Access Compliance Report

Public Rights-of-Way

Intersection ID: 10027410	Main Street: GOLF_ACRES_DR	Cross Street: N/A	Location: SW
ADA ID: ED152FF7BB36	Ramp Type: Perp	Initial Pass/Fail: Fail	Overall Compliance: No
		Severity Score: 10

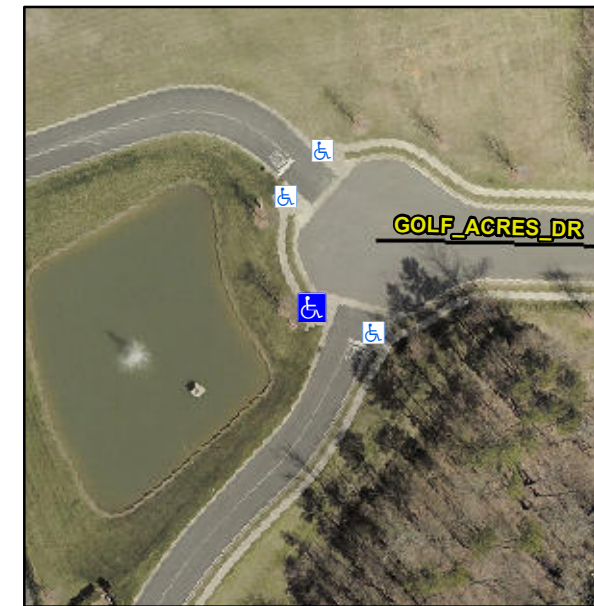
Not Found, R304.5.1, R304.5.3

Compliance	Description	Data	Compliance	Description	Data
N/A	Ramp Length (in)	47.5	Yes	Ramp Slope (%)	8.0
No	Ramp Width (in)	40.0	No	Ramp XSlope (%)	4.6
N/A	Flare Type LT	N/A	N/A	Flare Type RT	N/A
N/A	Flare Slope LT (%)	N/A	N/A	Flare Slope RT (%)	N/A
N/A	Flare Traversable LT?	N/A	N/A	Flare Traversable RT?	N/A
N/A	Landing Length (in)	N/A	N/A	DWS Provided?	N/A
N/A	Landing Width (in)	N/A	N/A	DWS Contrast?	N/A
N/A	Landing Slope (%)	N/A	N/A	DWS Length (in)	N/A
N/A	Landing X Slope (%)	N/A	N/A	DWS Full Width?	N/A
N/A	Landing Curb? (Y/N)	N/A	N/A	DWS Offset (in)	N/A
N/A	Shared Landing?	N/A			
N/A	Gutter Ponding?	N/A	N/A	Gutter Slope (%)	N/A
N/A	Gutter Lip Ht (in)	N/A	N/A	Gutter X Slope (%)	N/A
N/A	Painted X Walk1?	No	N/A	Painted X Walk2?	N/A
	X Walk 1 Direction	To SE		X Walk 2 Direction	N/A
N/A	X Walk 1 Width (in)	N/A	N/A	X Walk 2 Width (in)	N/A
	X Walk 1 Slope (%)	0.8		X Walk 2 Slope (%)	N/A
	X Walk 1 X Slope (%)	3.0		X Walk 2 X Slope (%)	N/A

Remove & Replace Entire Ramp.
